METROPOLITAN GOVERNMENT OF NASHVILLE AND DAVIDSON COUNTY

STAFF RECOMMENDATION 1413 Lillian Street June 5, 2015

Application: New construction—addition
District: Lockeland Springs-East End Neighborhood Conservation Zoning Overlay
Council District: 06
Map and Parcel Number: 08313031400
Applicant: John TeSelle, AIA
Project Lead: Melissa Baldock, melissa.baldock@nashville.gov

Description of Project: Application is to construct a rear addition. The addition is wider than the historic house.

1 EAST ELEVATION
 0 2' 4' 8' 16' 32'

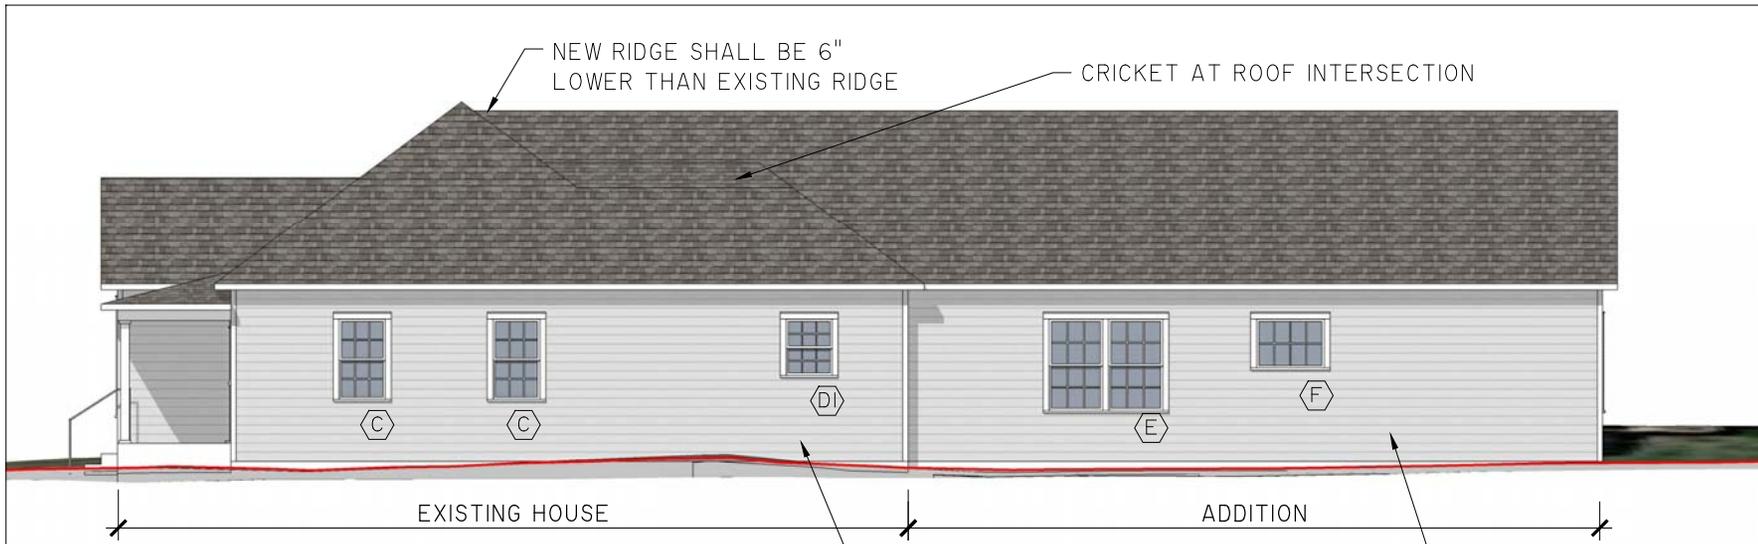
Rhythm and Proportion of Openings: The drawings indicate that the applicant plans to re-create the historic house's window pattern with one exception. On the right/east façade, towards the rear, a window opening will be shortened. Staff finds this appropriate since the window is located so far back on the side façade. The windows on the addition are generally twice as tall as they are wide. There are no large expanses of wall space without a window or door opening. Staff therefore finds that the addition meets Sections II.B.7. and II.B.10. of the design guidelines.

WEST ELEVATION

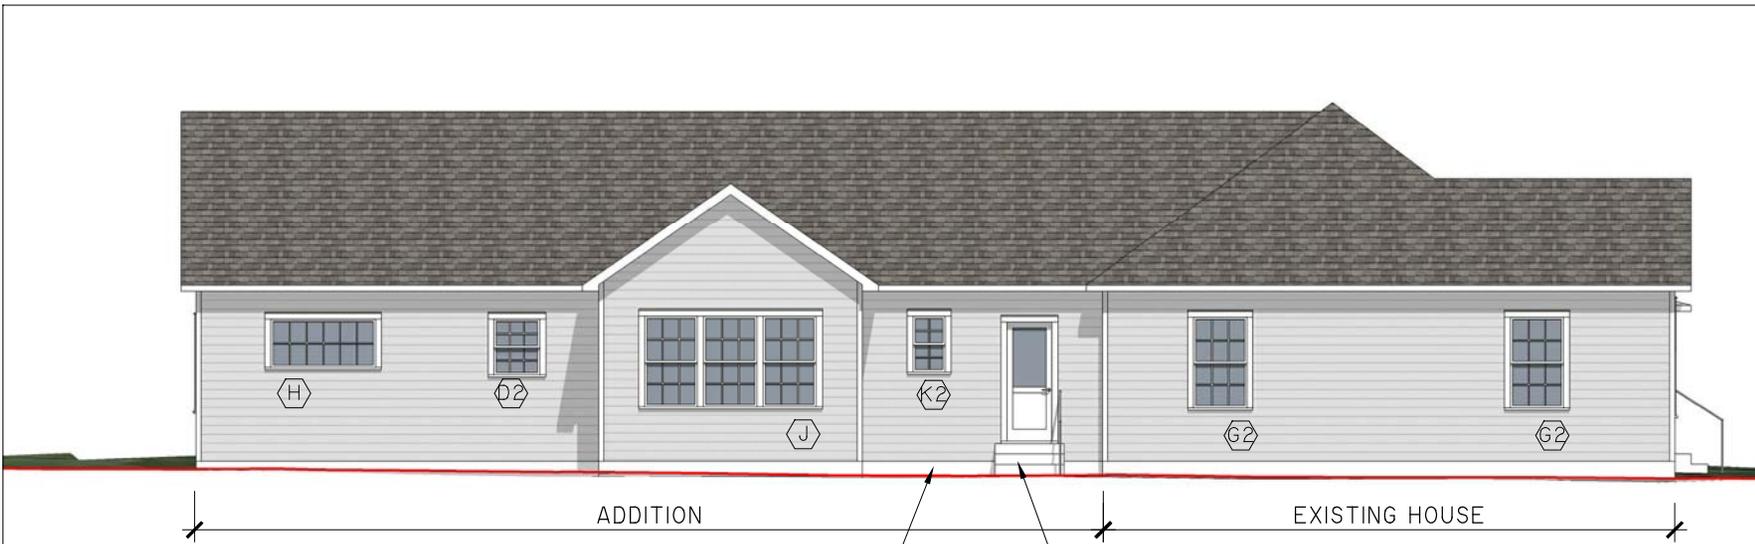
Orientation: The addition will not alter the orientation of the house towards Lillian Street. A new side entrance will be created on the left/west side façade. This entrance

will not be covered and is a simple doorway design. It will clearly read as a secondary side entrance. Vehicular access to the site is via the rear alley. Staff finds that the addition's orientation meets Sections II.B.6. and II.B.10 of the design guidelines.
